# CITY OF ALBUQUERQUE

**RE: Legacy Uptown Apartments  
Conceptual Grading and Drainage Plan  
Engineer's Stamp Date: 10/02/18  
Hydrology File: J18D033**

Based upon the information provided in your resubmittal received 10/04/2018, the Conceptual Grading and Drainage Plan is approved for action by the DRB on the Site Plan for Building Permit.

SHEET TITLE:  
CONCEPTUAL  
DRAINAGE PLAN

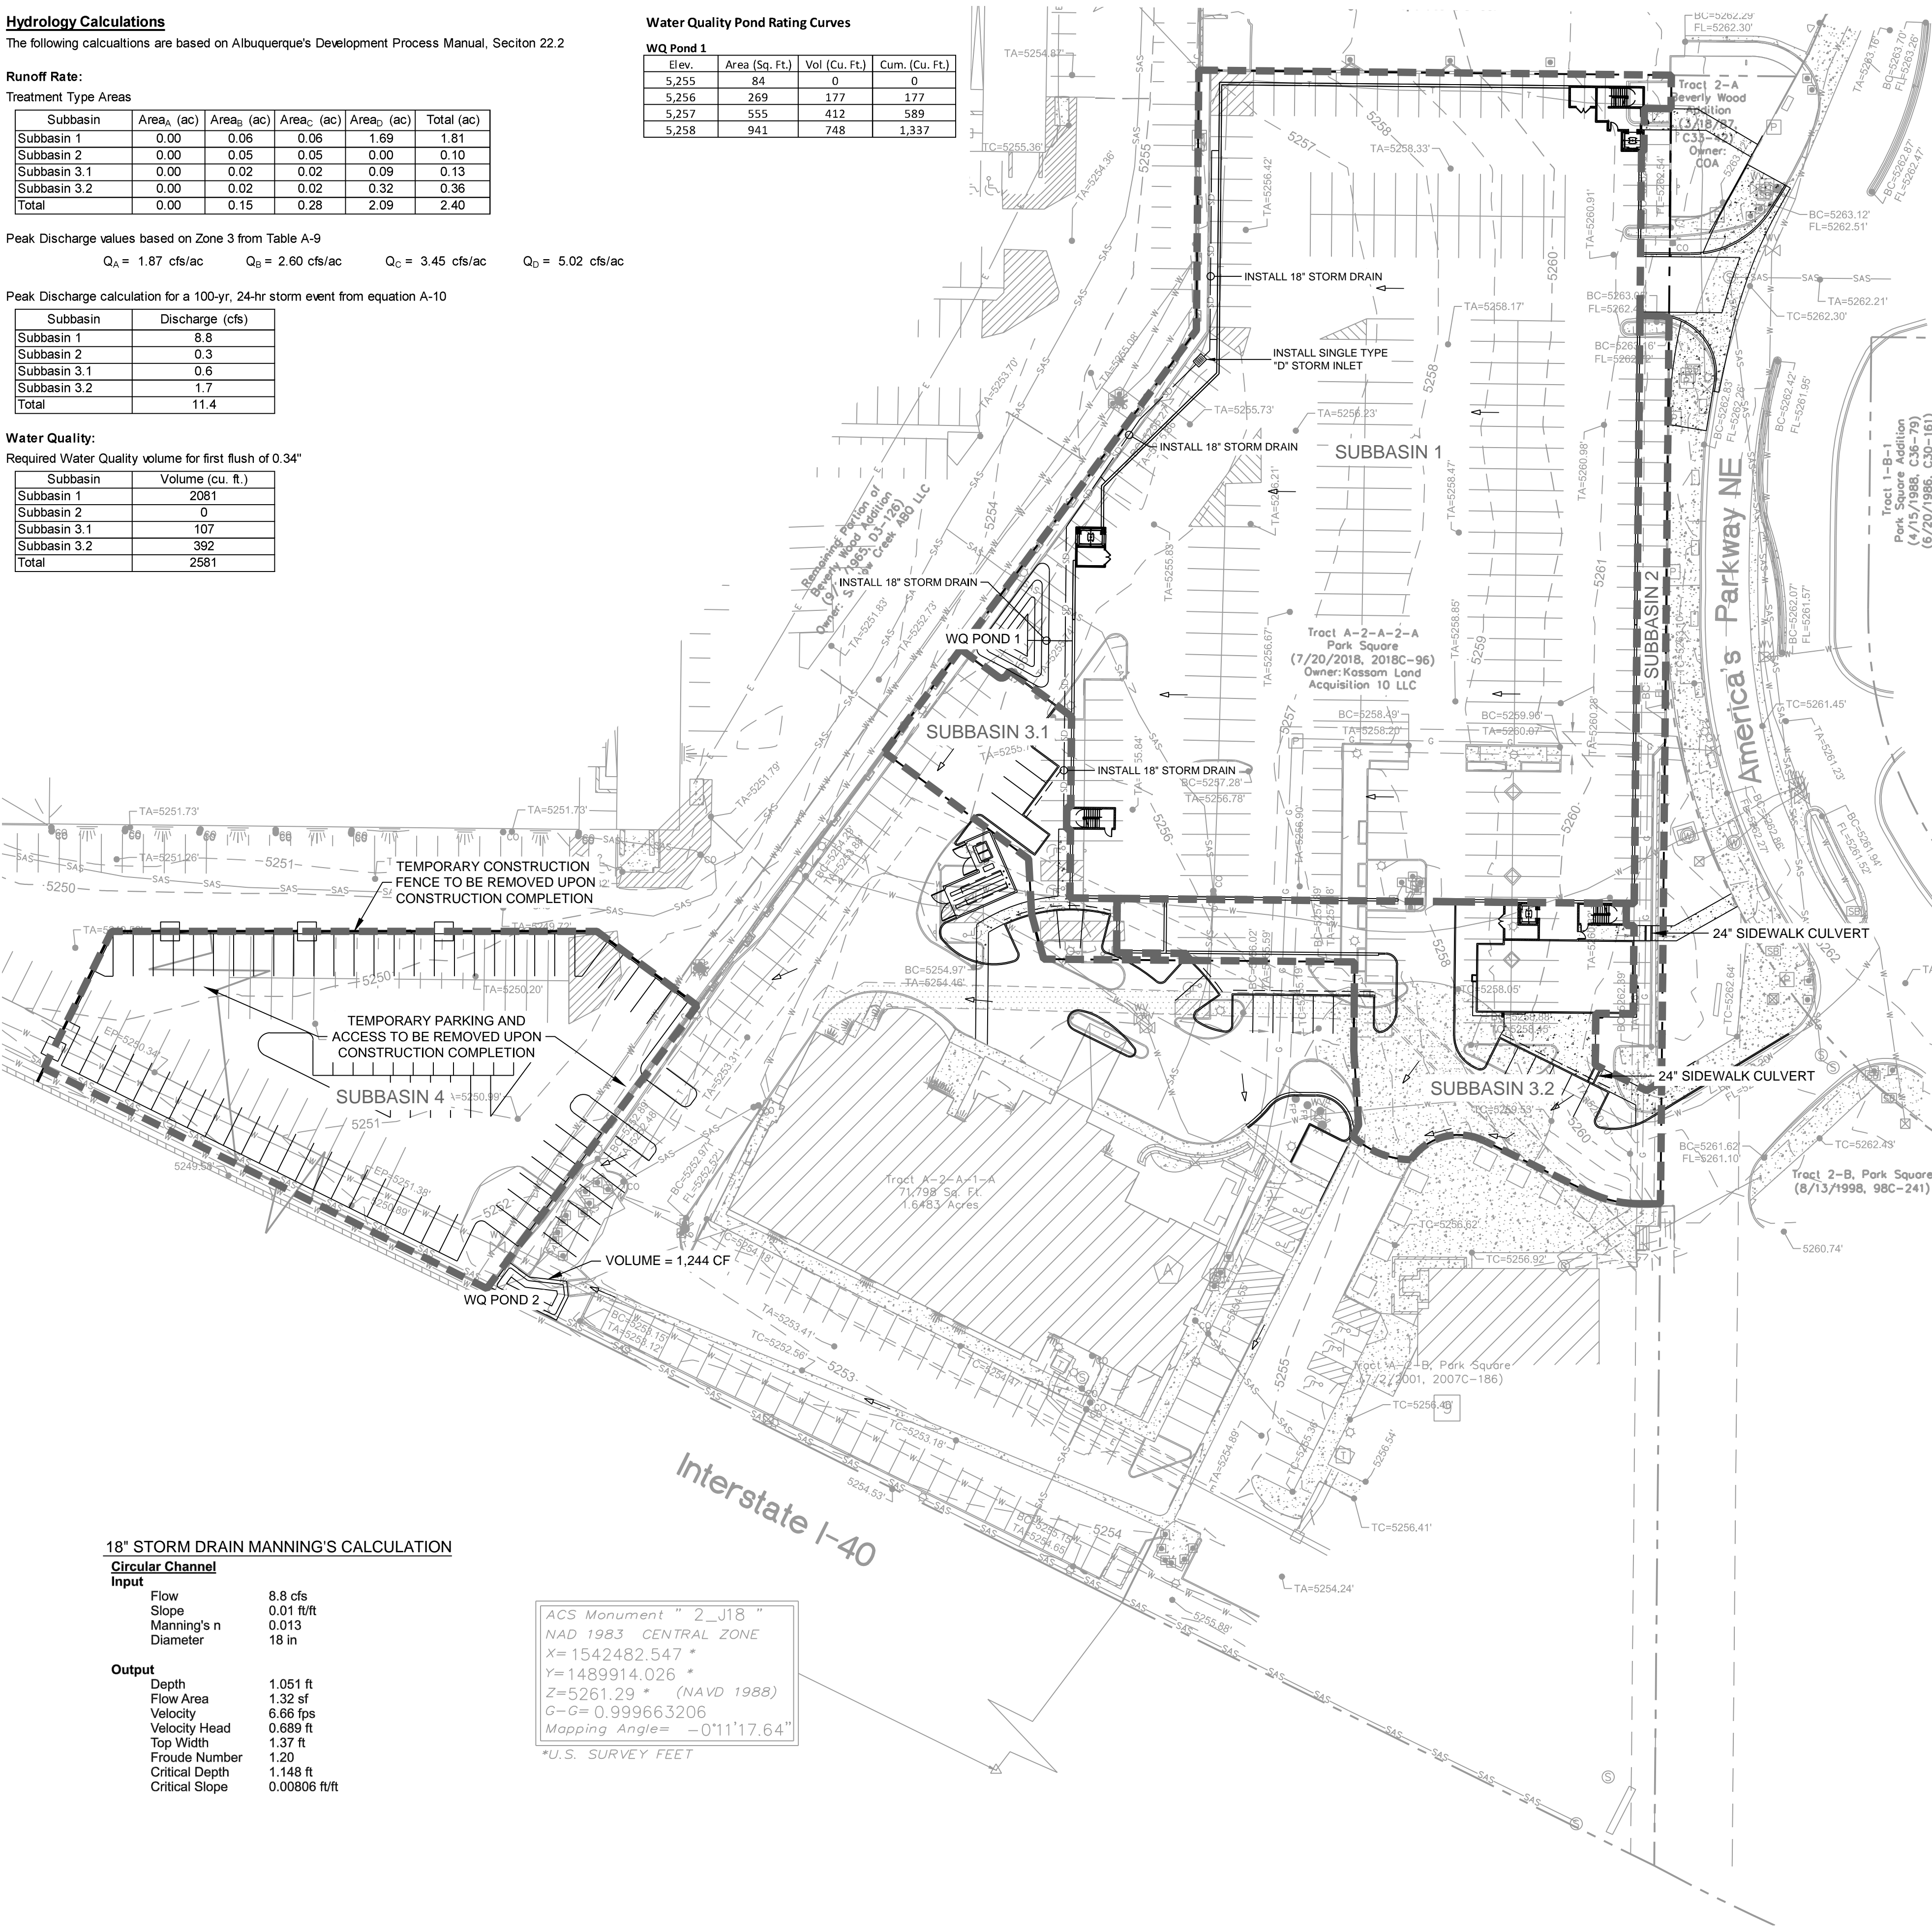
As a reminder, please provide a Private Facility Drainage Covenant per Chapter 17 of the DPM for the first flush ponds prior to Certificate of Occupancy.
